DESIGN REVIEW & EXCELLENCE PANEL RESPONSE REPORT

14-16 MARSHALL AVE, 2-10 BERRY RD & 5-9 HOLDSWORTH AVE, ST LEONARDS

DEVELOPMENT APPLICATION

May 2023

Building Setbacks A: - From Berry Road and Holdsworth Avenue requires:

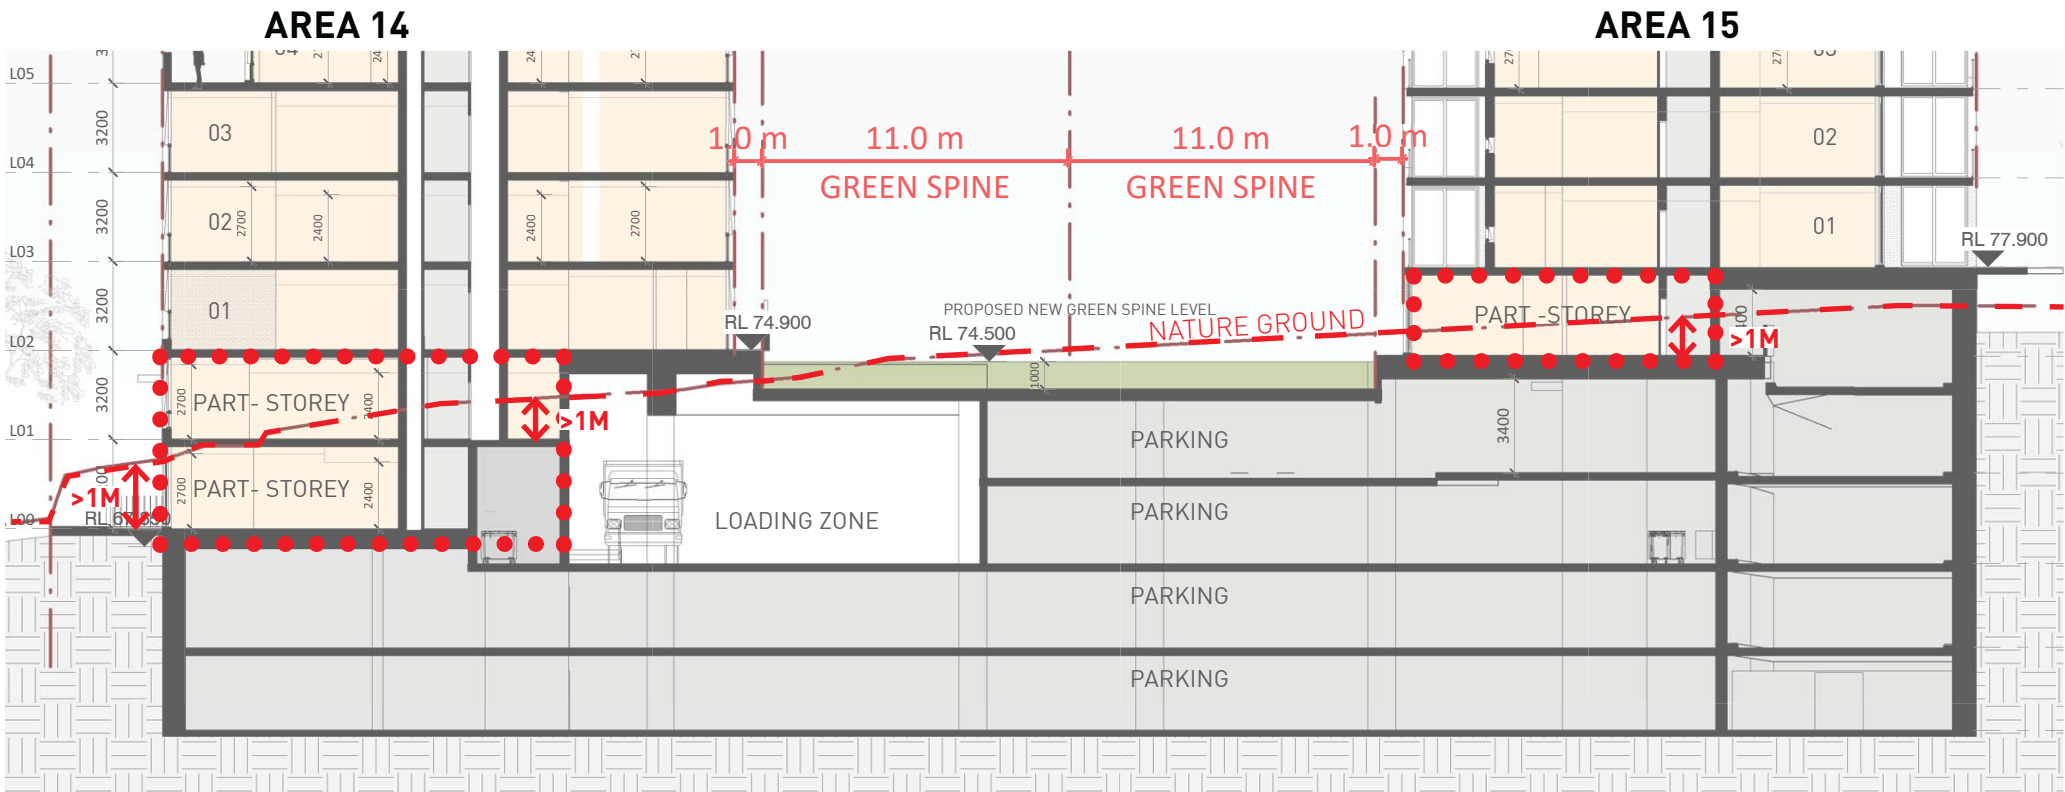
- 4m at street level up to level 5
- 7m at level 6 and above.

Podium levels amended to 5 storeys from the natural ground level.

Comment: The first 5 storeys (podium) are setback 4m from the street boundary, and the upper levels is setback 7m in compliance with the DCP controls.

2.2 East/West Link

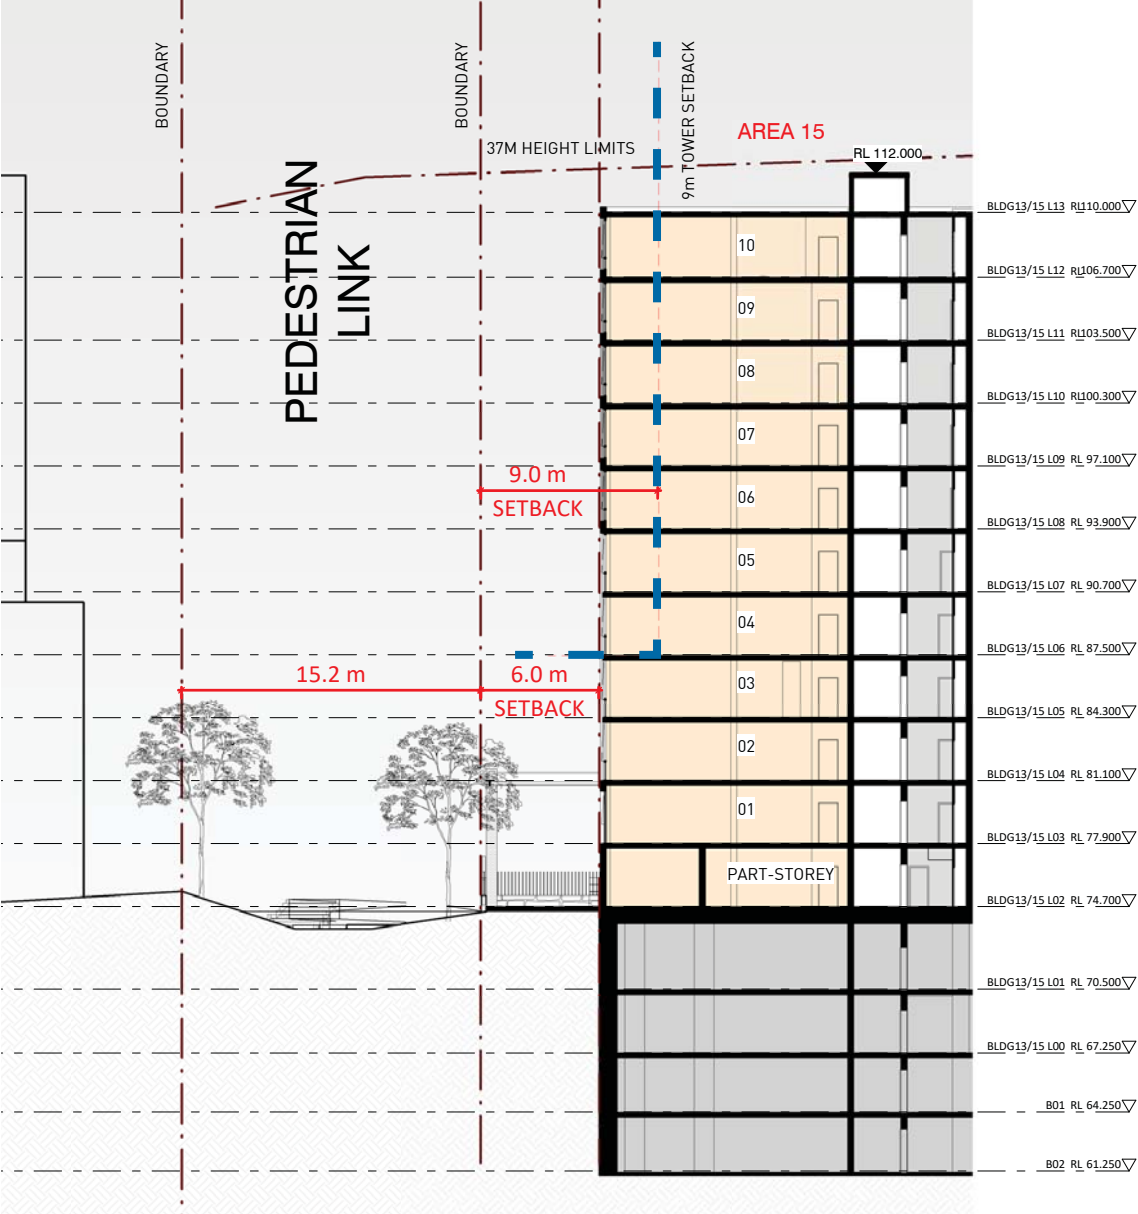
Buildings Setbacks F: - from east/west pedestrian link requires:

Figure 1: Non-complaint setbacks for Bldg 14.

Comment: Prior to DA lodgement, (Areas 14 and 15) should be amended to comply with the 9m setback. Please be advised that both Council and the community have a strong expectation that the proposal fully complies with the DCP setback controls.

RESPONSE:

This urban design analysis of the proposed southern setbacks of the proposed development finds that, due to the unique circumstances of the site, considering the generous 15-metre- wide pedestrian link reserve, the proposed 6-metre southern setback of the proposed development is sufficient to provide an overall building separation that exceed the separation distances required by Parts 2F and 3F of the Apartment Design Guide under SEPP 65.

3. North-South Green Spine Levels:

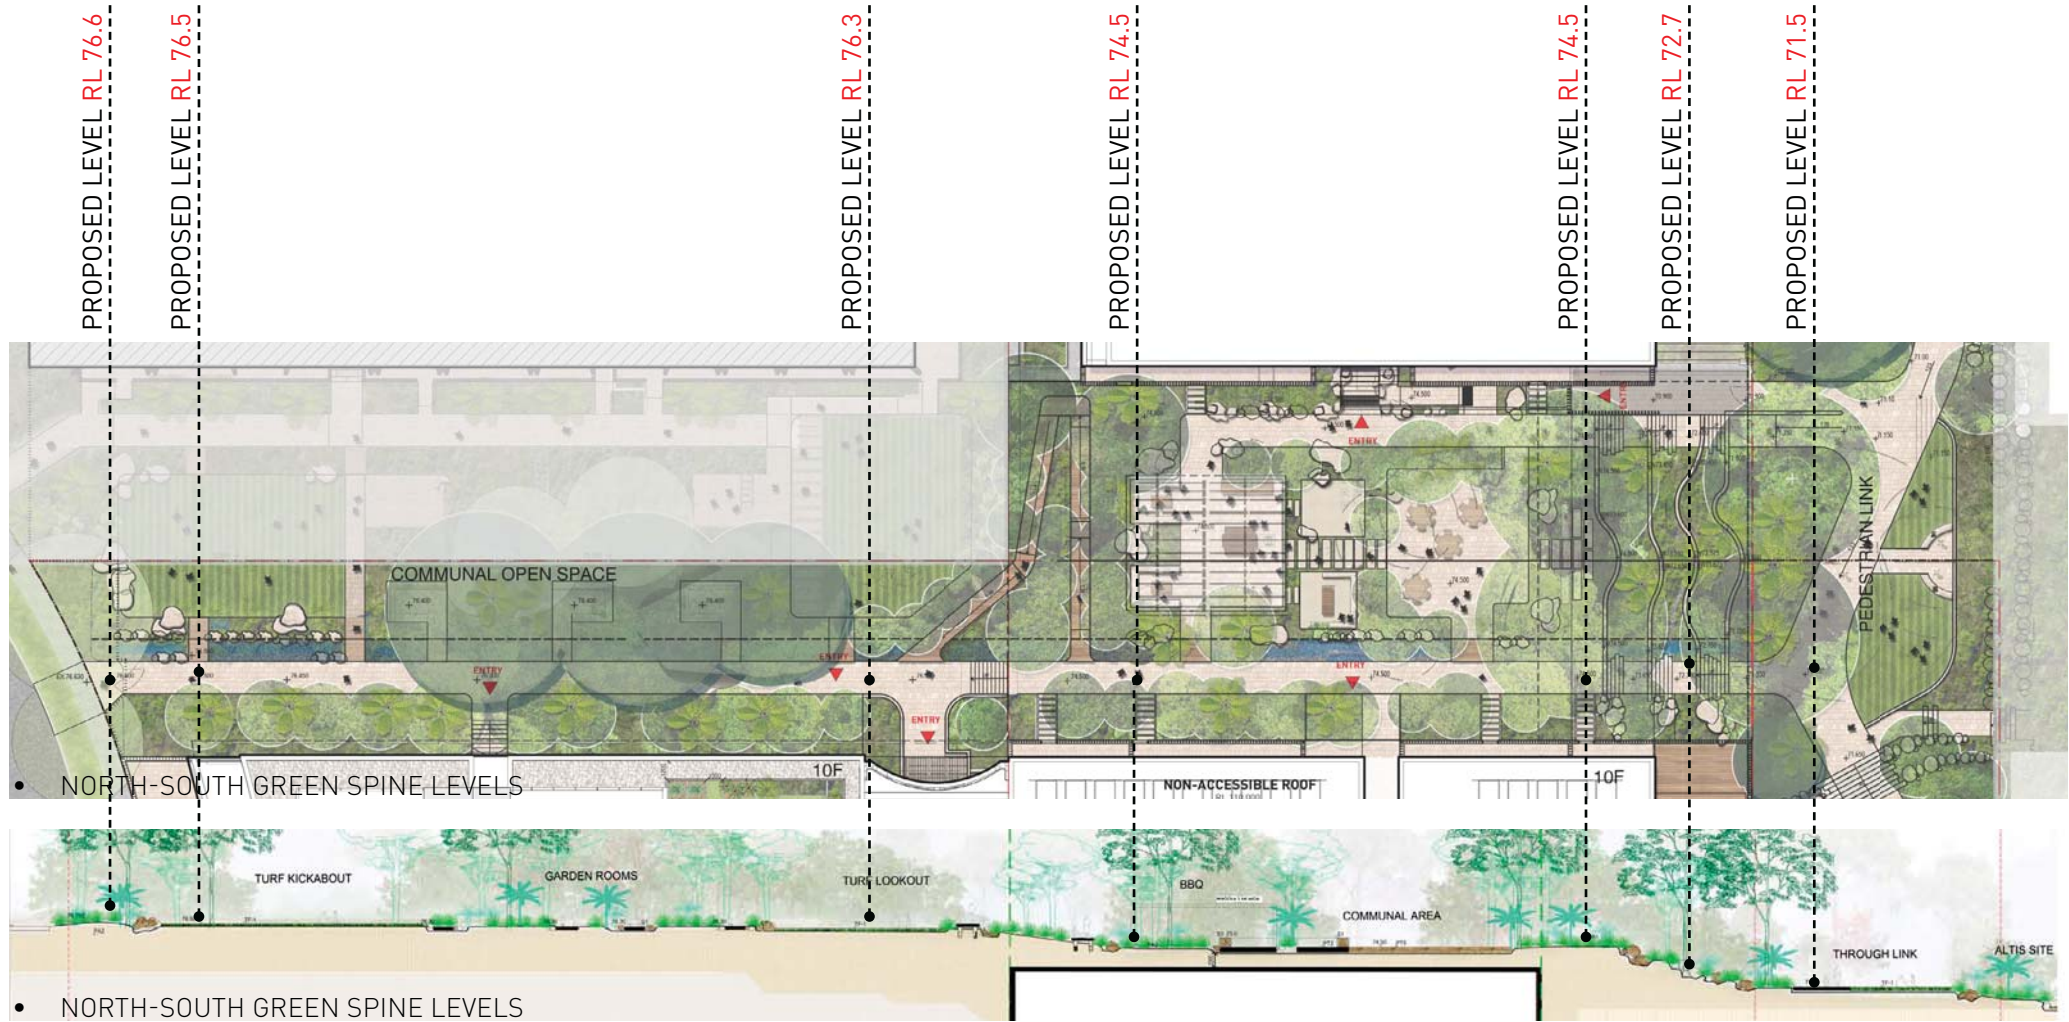
LMP North-South Green Spine Levels Requirement:

- Between Areas 13 and 12 RL77.00
- Between Areas 14 and 14 RL75.00

Comment: The southern portion of the North-South Green Spine level (between Areas 14 and 15) has been revised from RL71.6 to RL 74.5 The northern portion of North-South Green Spine has been provided at RL 76.00. The northern RL is similar to connected North-South Green Spine section at Area 12 which is proposed to be approximately RL 76.50. The revised RL levels are generally consistent with the LMP and considered acceptable for lodgement.

- The proposed North-South Green Spine level is consistent with Council's landscape master plan

5. Encroachments into North-South Green Spine.

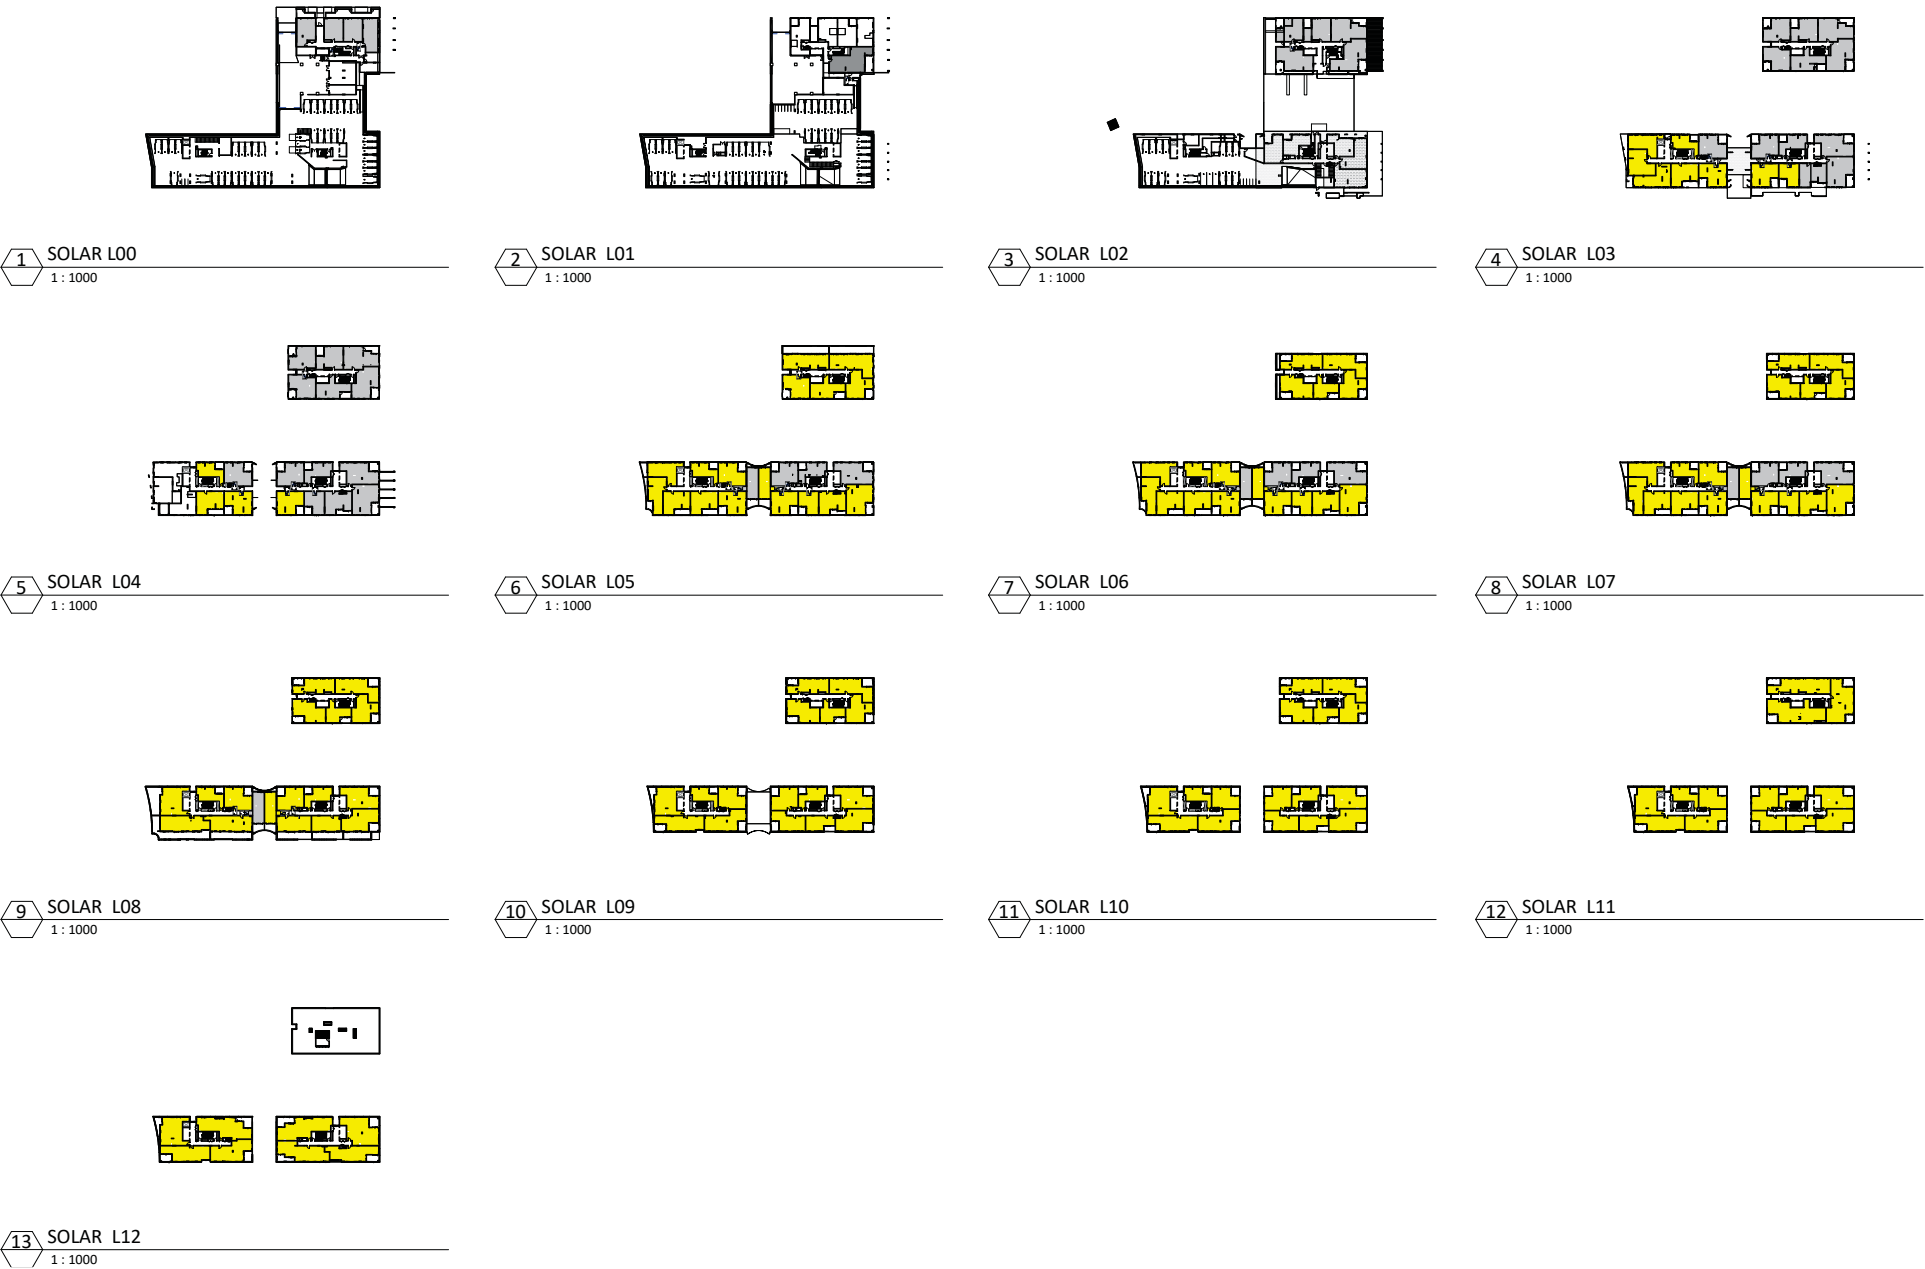
Structured Deep Soil: As part of the submitted DA design, there should be minimum depth of 1.5m for structured soil (soil above basement carparks) within the North-South Green Spine to accommodate the planting of mature canopy trees.

Unencumbered Deep Soil: Measures should be undertaken to reduce non-permeable areas within deep soil zones including but not limited to.

- Maintain no exceeding over the 2.5M height control in the North-South Green Spine area
- Proposed landscape pergola over BBQ area which is under 2.5m height control
- Min. 1M depth for structured soil (over carparks) within North-South Green Spine to accommodate the planting of mature canopy trees, also total of 894.8m² (50% of North-South Green Spine area) deep soil at North-South Green Spine are provided

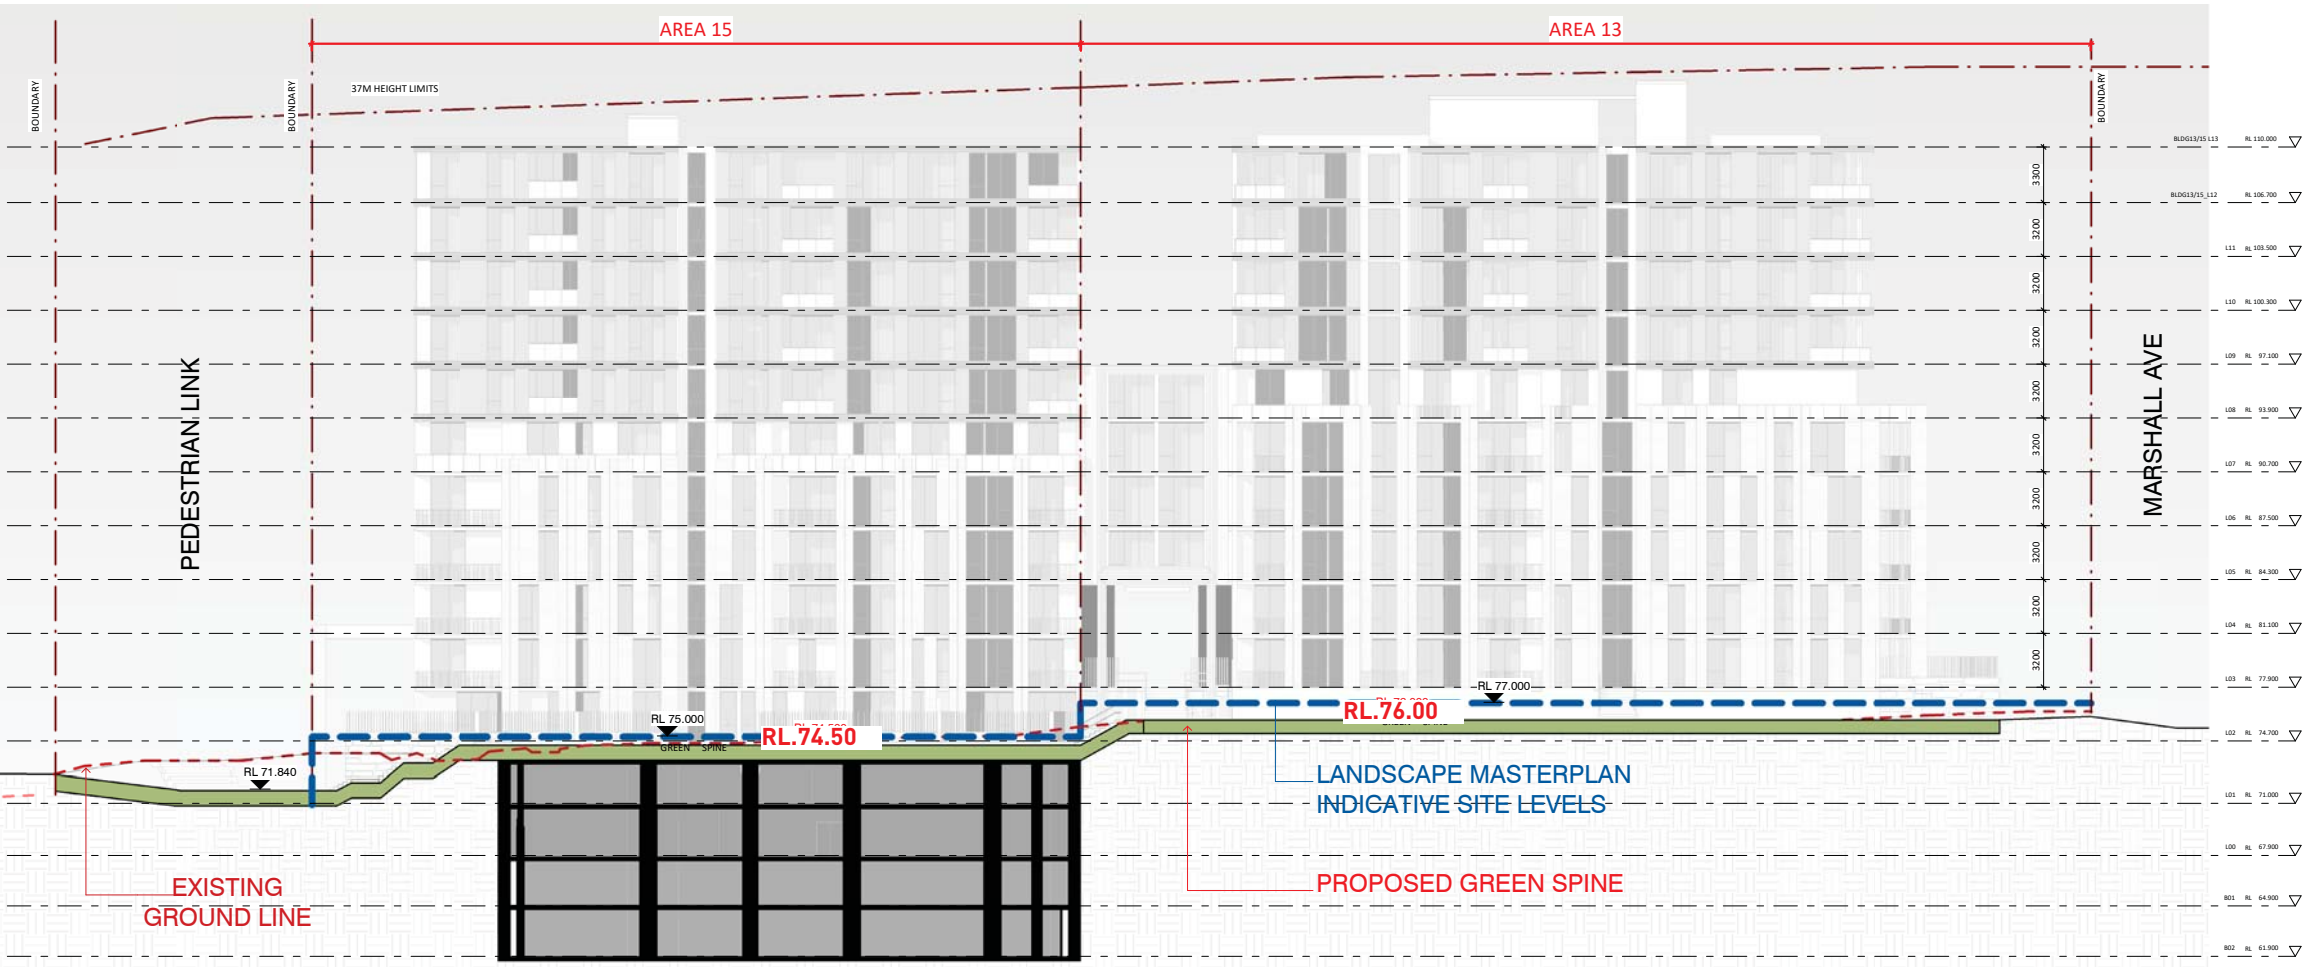
The proposed levels of the green spine continue to be inconsistent with the LMP and DCP levels.

Although the amended design reduces the severity of excavation below, the levels are still contrary to the intent and controls of the LMP. The amended design includes a series of steps 5m down from north platform to south platform.

- Top platform has an RL of 76 – 74.9
- Bottom platform drops to RL 71.6 (required to be RL75)

- The Southern part of Green Spine level has been revised from RL71.6 to RL 74.5
- To minimize level difference between northern and southern green spine, RL76.00 for northern green spine has been provided.
- The proposed green spine level is consistent with Council’s landscape master plan
